East Park Energy

EN010141

Applicant Responses to Relevant Representations

Host Authorities, Statutory Environmental Bodies, and
Other Interested Parties

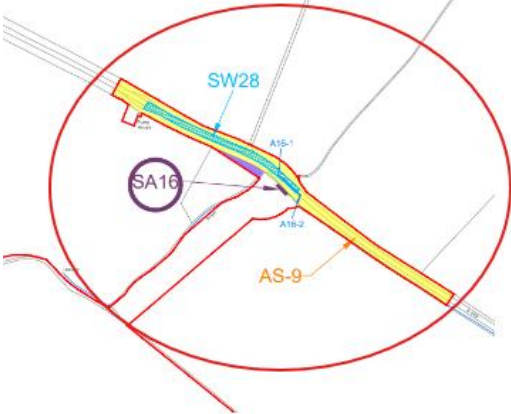
CCC-RR-40	7.20	Traffic and Transport	TTM 8 indicates part time traffic signals on the junction. This needs to be assessed and agreed with the council's Street Works Department.	The Applicant notes this requirement. The exact detail of the proposed traffic management will be discussed and agreed with CCC's Street Works Department in advance of construction commencing, as set out in Section 5.5 of the outline Construction Traffic Management Plan (as updated alongside this submission) , as secured via Requirement 8 of the draft DCO [AS-008] .
CCC-RR-41	7.21	Traffic and Transport	Within document [APP-010], EN010141/DR/2.4 Street works, Rights of Way and Access Plan P01, 3149-2.4-010 reference AS 9 also indicates alteration of streets (permanent). The council's technical officers have been unable to find any information within the documents indicating what these works are. The council requests that the applicant submits these proposed works for assessment. There are also references A16-1 and A16-2 which the council has been unable to locate.	As set out within Schedule 5 Part 1 of the draft DCO [AS-008] , the proposed street works at this location are related to the provision of the permanent means of access into the Site at this location, which includes for the provision of the necessary visibility splays. The points A16-1 and A16-2 indicate the exact position of the proposed access, as set out within Schedule 7 Part 1 of the draft DCO [AS-008] .

LOCATION PLAN EXTRACT
OF PIPELINE S/K

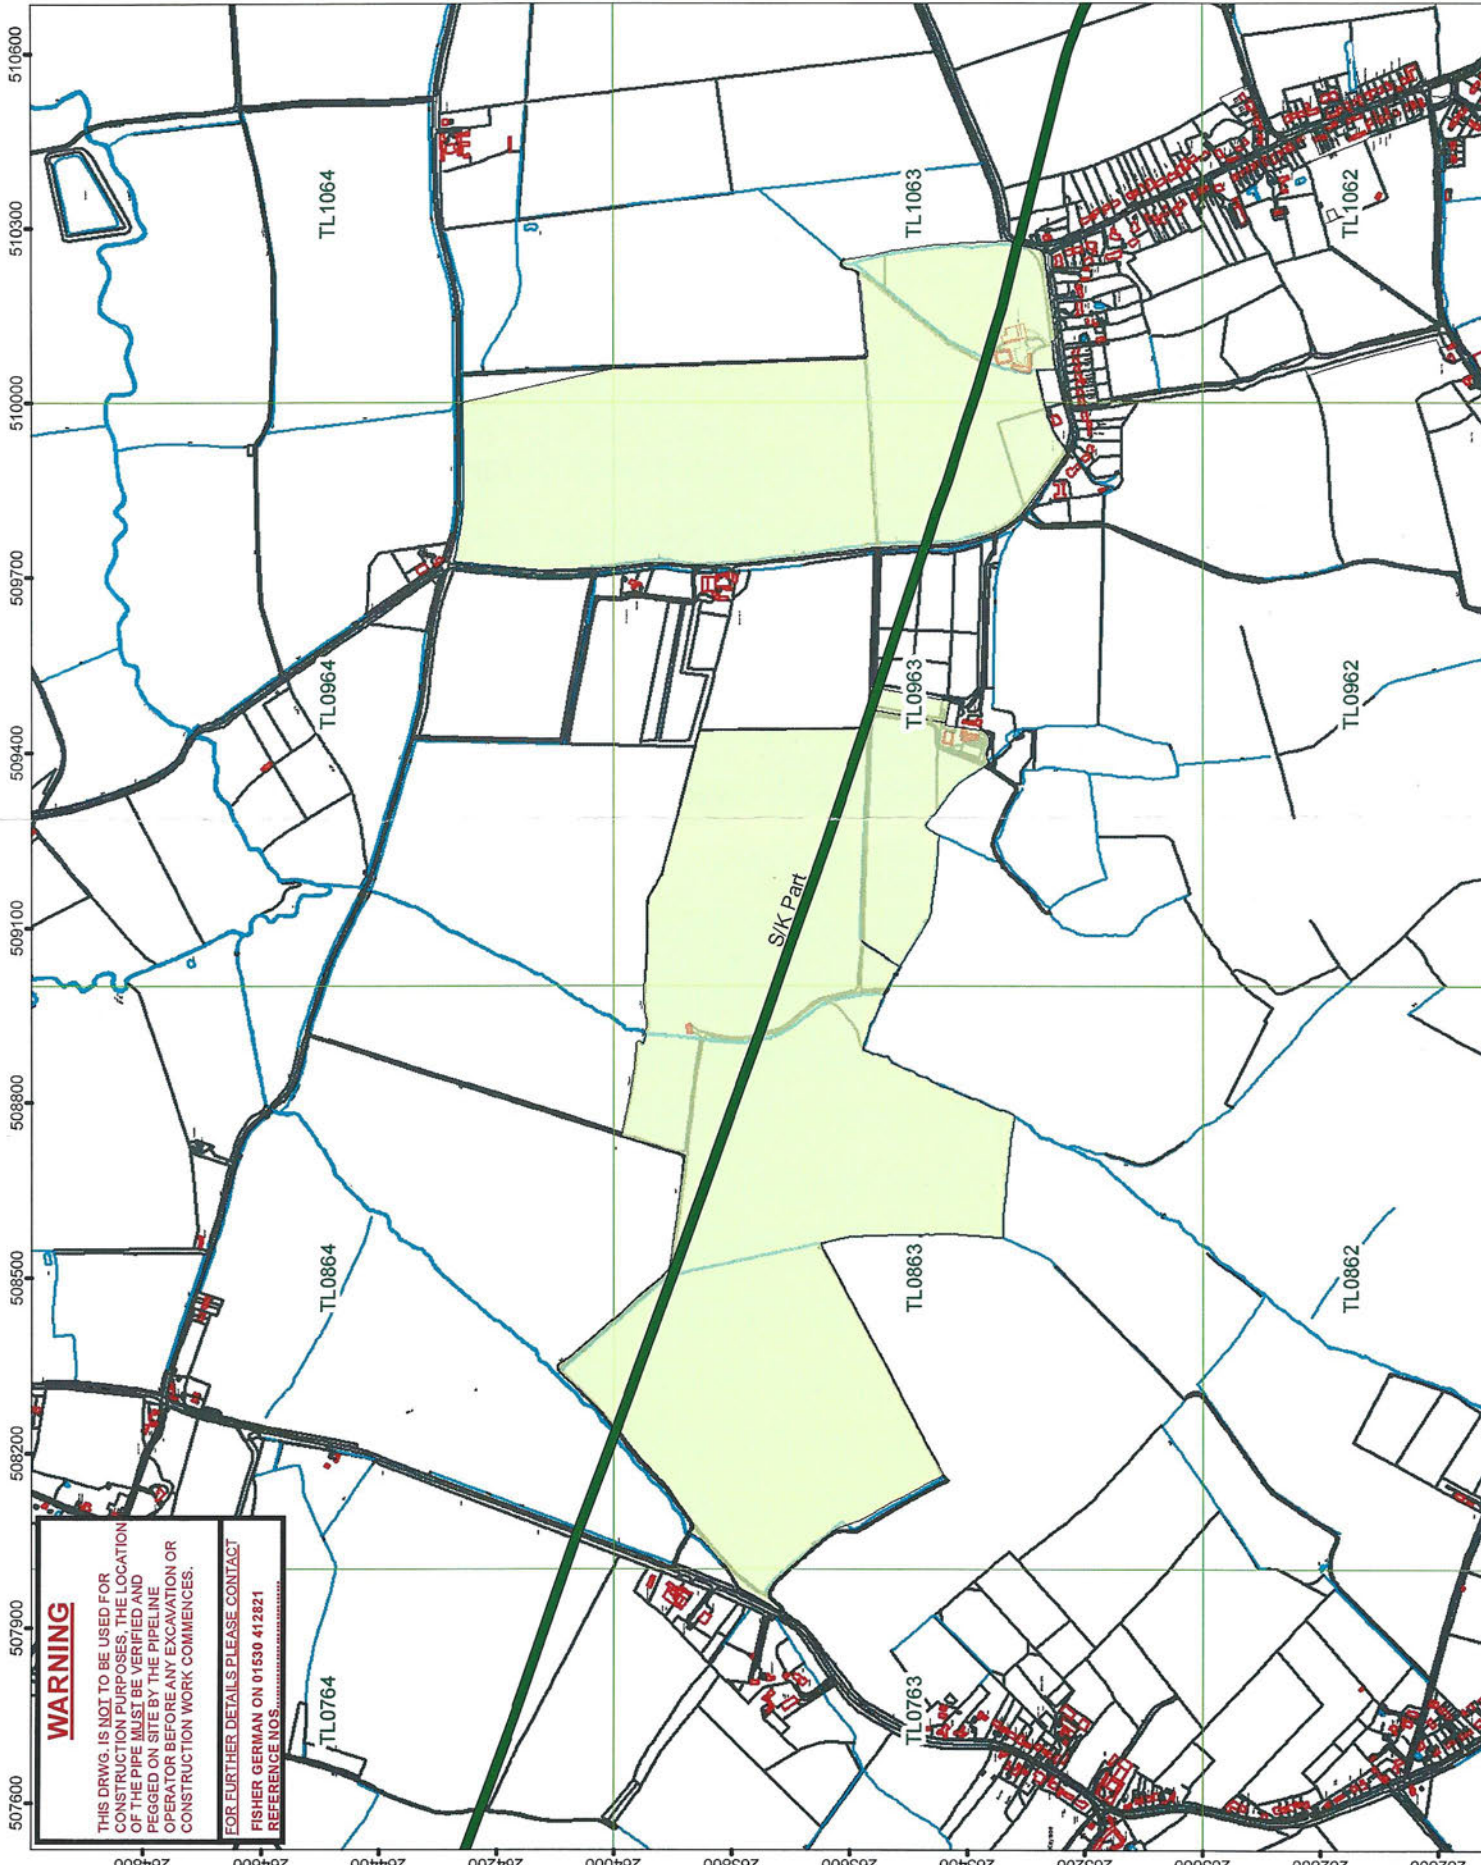
BBC-RR-161	19.5	Utilities	<u>Matter 97</u> Oil pipeline: [APP-031] Planning Statement para3.2.15 – the Application does not make reference to the disused oil pipeline present within the landscape that might potentially impact upon Sites A and B and will need to be addressed (para4.7.23 and ES Vol 3 Figure 2-3: Indicative Crossings Plan [EN010141/DR/6.3] refers). The Applicant will need to demonstrate that discussions have been held with the infrastructure owner and that the ES demonstrates an approach to potential residual risk.	The Applicant does explicitly address the decommissioned oil pipeline, which is noted at paragraph 4.7.23 of the Planning Statement [APP-031], and shown on ES Vol 3 Figure 2-3 Indicative Crossings Plan [APP-123]. The Applicant notes that the linework for the 'Former Oil Pipeline' on Figures 2-3b and 2-3c [APP-123] is faint and only more visible when zooming in on the PDF. The Applicant has therefore updated ES Vol 3 Figure 2-3 Indicative Crossings Plan [as updated alongside this submission] to improve the clarity of the figure.
